BUILDING PERMIT REPORT

DATE: 10 June 99 ADDRESS: 16 Ragan Lane CBL: 348-C-045
 REASON FOR PERMIT: To Construct 14' x 22' garage (Private)
 BUILDING OWNER: Handron
 PERMIT APPLICANT: Affordable Window Siding
 USE GROUP U BOCA 1996 CONSTRUCTION TYPE 5B

**Building or Use Permit Pre-Application
Additions/Alterations/Accessory Structures
To Detached Single Family Dwelling**

16 Regan
Portland
Neil + Florence
Handron

Revised Plot
Plan - received
6/9/99

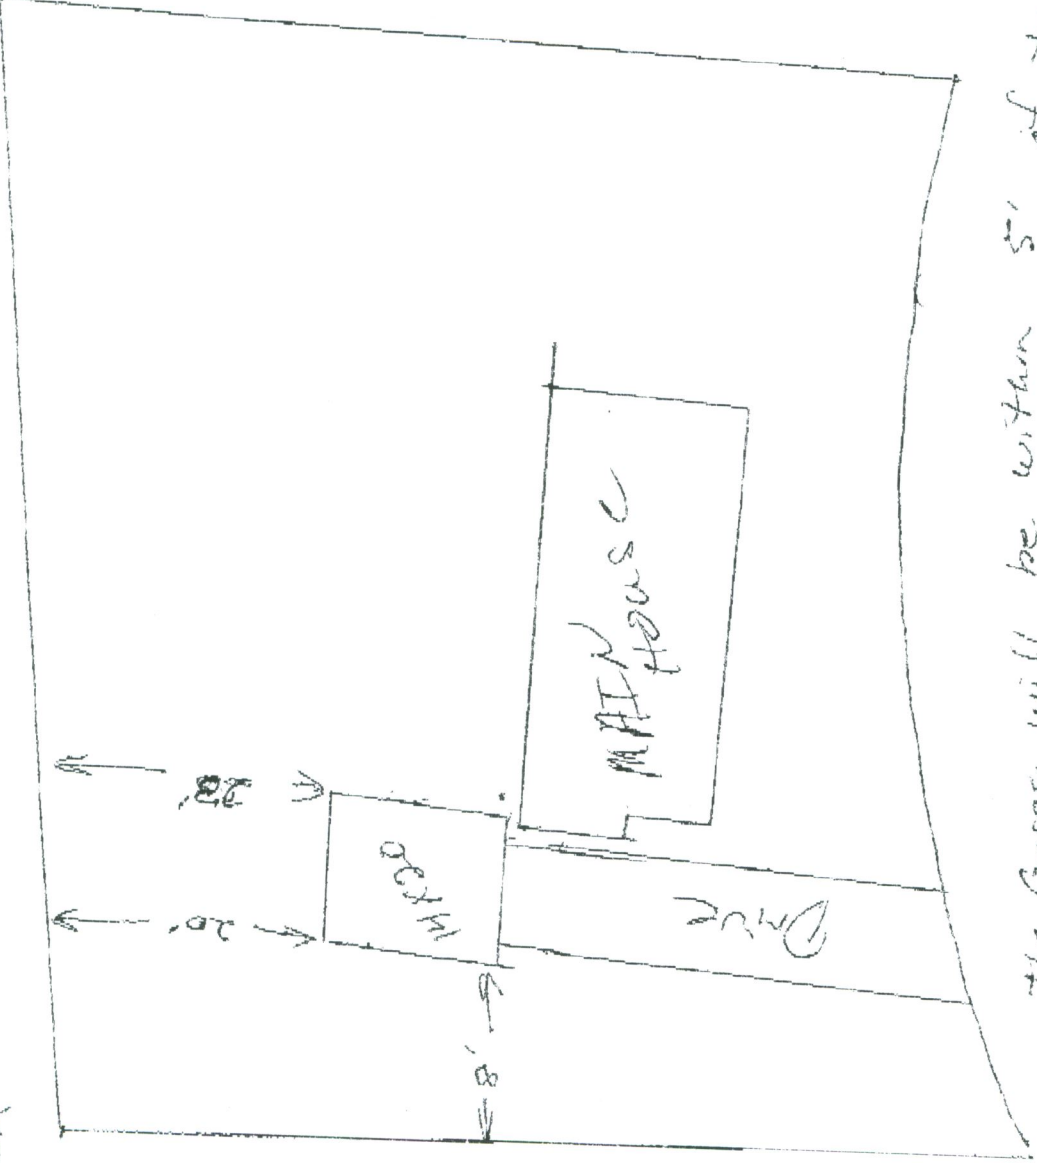
no closer

20' ok on rear

per Sec. 14-433

9' reg on side -

9' shown

OK
[Signature]

The Garage will be within 5' of the house
we will fire wall front and side

of the garage to meet code as discussed.

16 Regan
 Portland
 Neil + Florence
 Handron

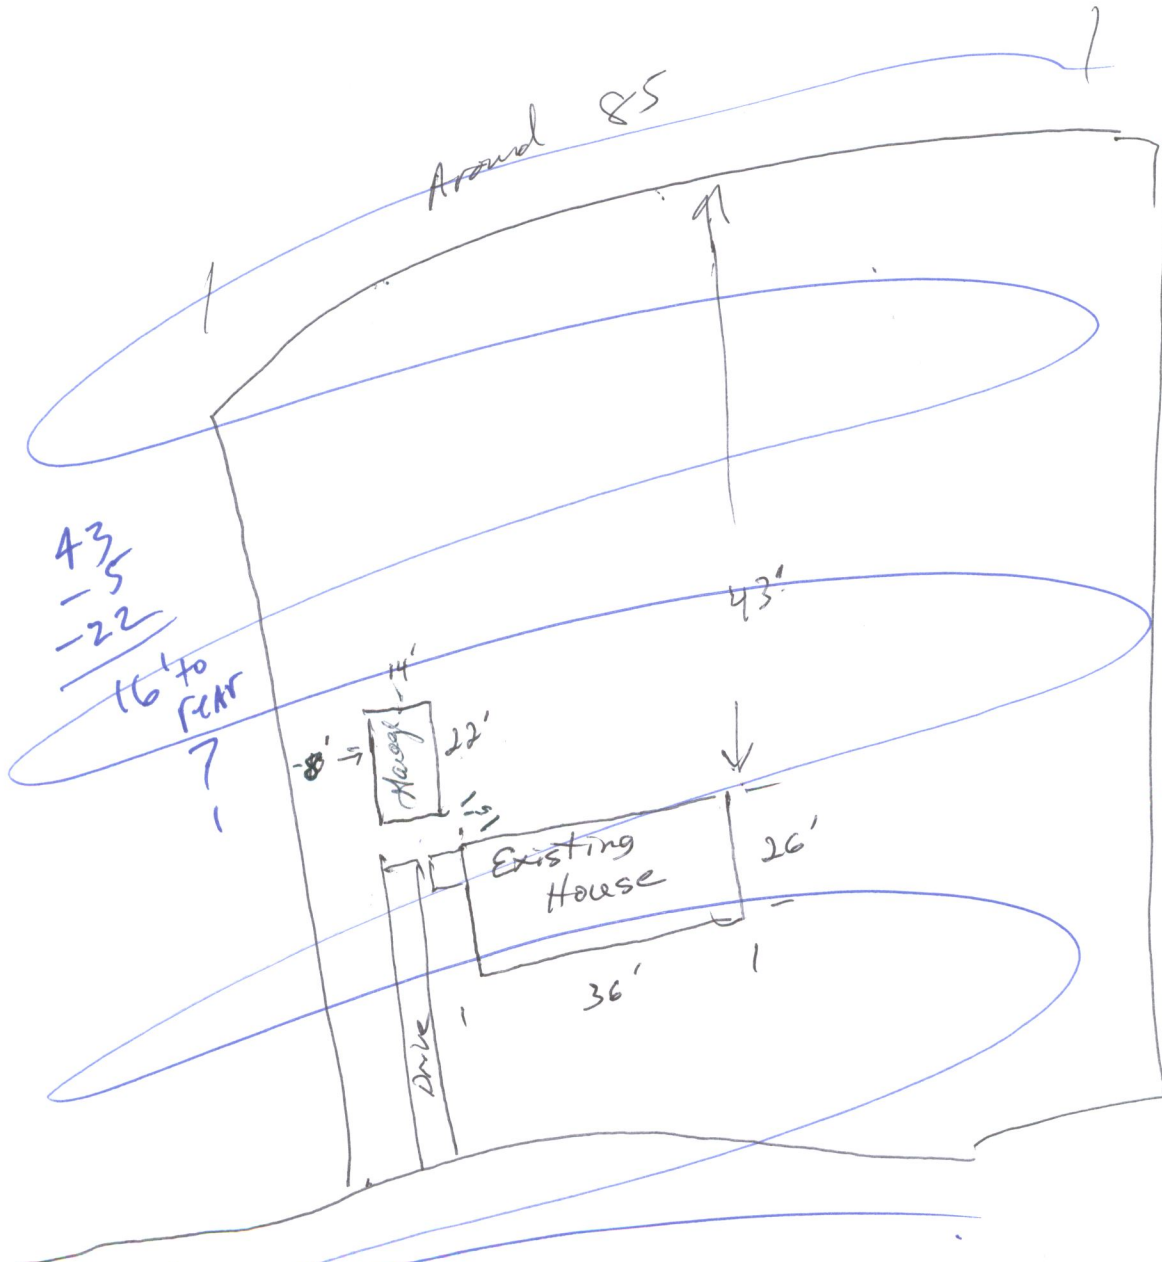
See REVISED
 plan received
 6/9/99
